**PLANNING ACT 2008
APPLICATION BY HIGHWAYS ENGLAND FOR AN ORDER GRANTING DEVELOPMENT CONSENT FOR THE A303 SPARKFORD TO
ILCHESTER DUALLING**

SUBMISSION MADE PURSUANT TO DEADLINE 5

South Somerset District Council's Response to the Examining Authority's written questions and requests for information (ExQ2)

South Somerset District Council's Hearing Action Points for D5

Examining Authority's Written Questions and Requests for Information (D5) – Q2.3.5 – Yeovilton Safeguarding Map

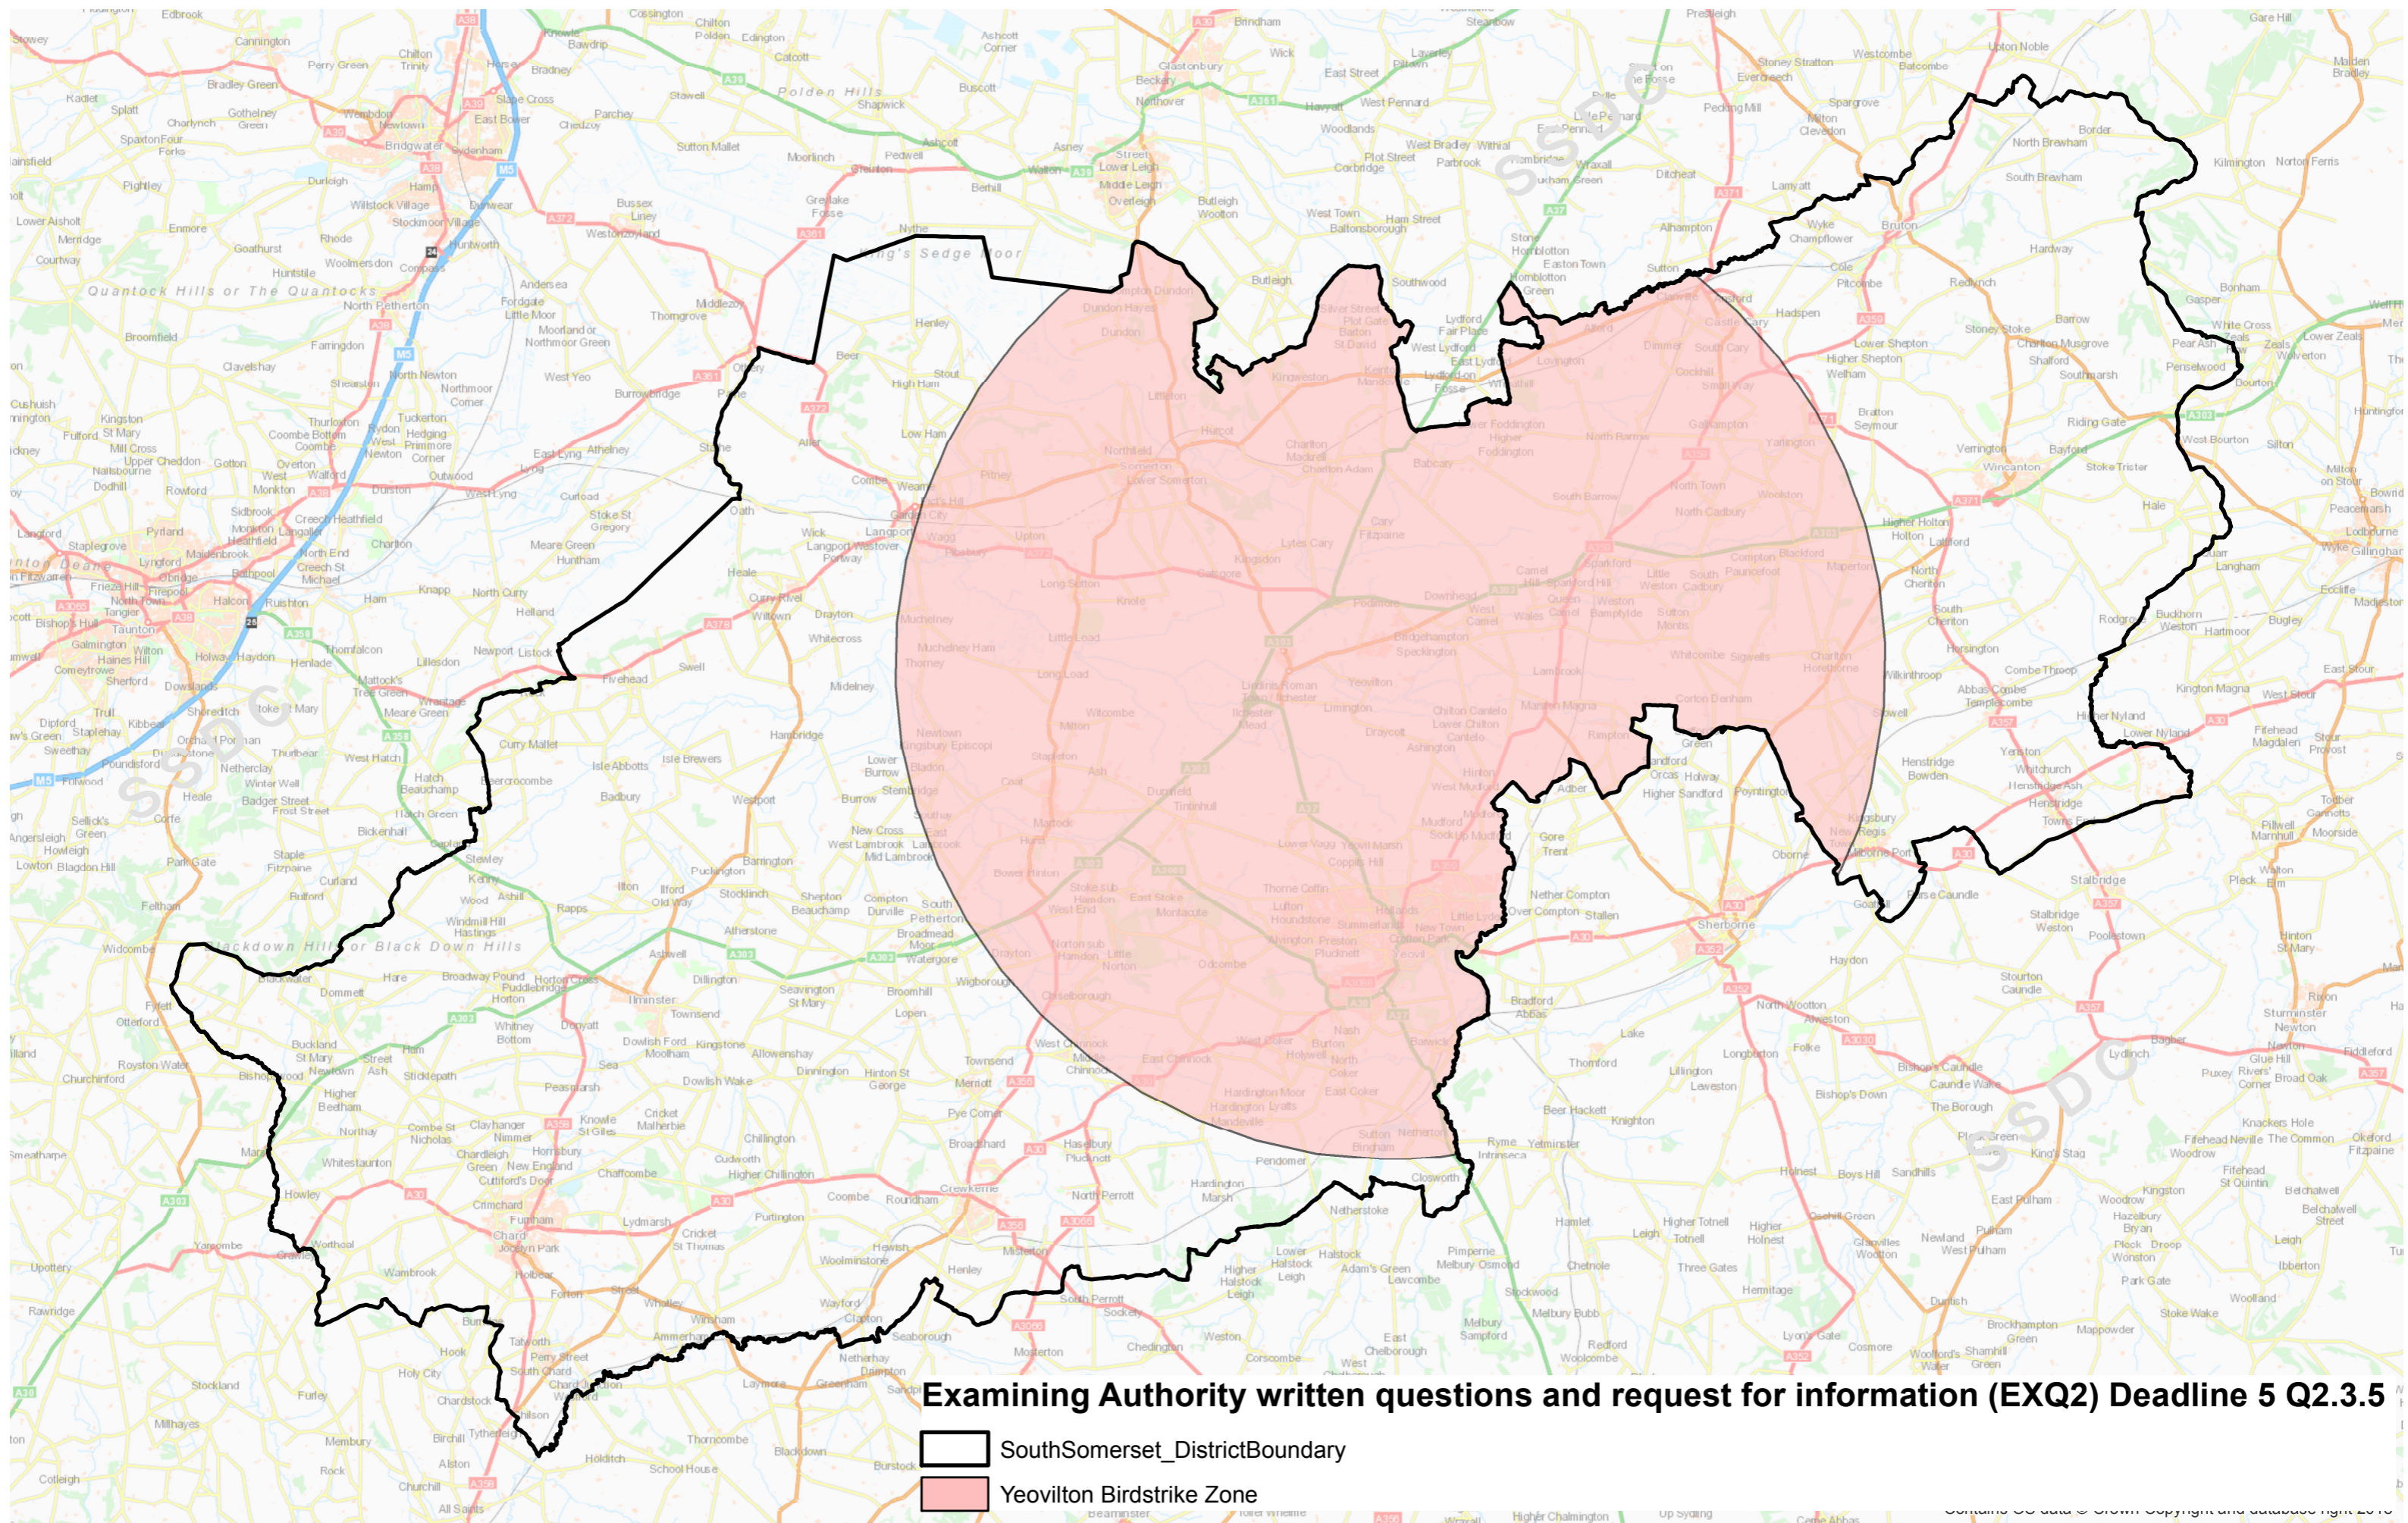
ExQ2	Question to:	Question:	
2.3.4	SSDC Natural England	<p>Biodiversity Offsetting Metric The Applicant submitted a report outlining a Biodiversity Offsetting Metric [REP4-017].</p> <p>(a) Do the parties agree with the approach undertaken and the findings.</p> <p>(b) If not, could they please fully explain and justify such a position.</p>	The Council's specialist Ecologist is satisfied with the approach undertaken and the findings of the Biodiversity Offsetting Metric.
2.3.5	SSDC DIO	<p>RNAS Yeovilton Could SSDC please provide a copy of the safeguarding map provided to it in relation to RNAS Yeovilton along with any information that it may have in respect of potential birdstrike.</p>	A map of the birdstrike zone and Yeovilton safeguarding consultation zones is submitted alongside these responses to the Examining authority's questions.
